RHODE ISLAND DEPARTMENT OF TRANSPORTATION

Atwells Ave Bridge No. 975 Replacement

NOTICE TO PROSPECTIVE BIDDERS

ADDENDUM NO. 3 Prospective bidders and all concerned are hereby notified of the following changes in the Plans, Specifications, Proposal and Distribution of Quantities for this contract. These changes shall be incorporated in the Plans, Specifications, Proposal and Distribution of Quantities, and shall become an integral part of the Contract Documents.

REVISION TO
STEEL DETAILS

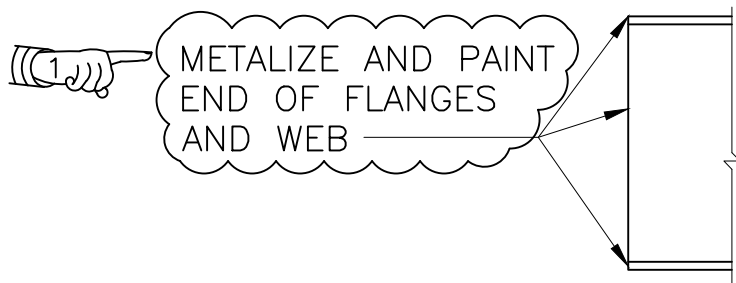
2. Sheet 18 - Steel Details

Modify this plan as shown on Sketch No. 1 attached to this Addendum No. 3. Paint limit has been revised.
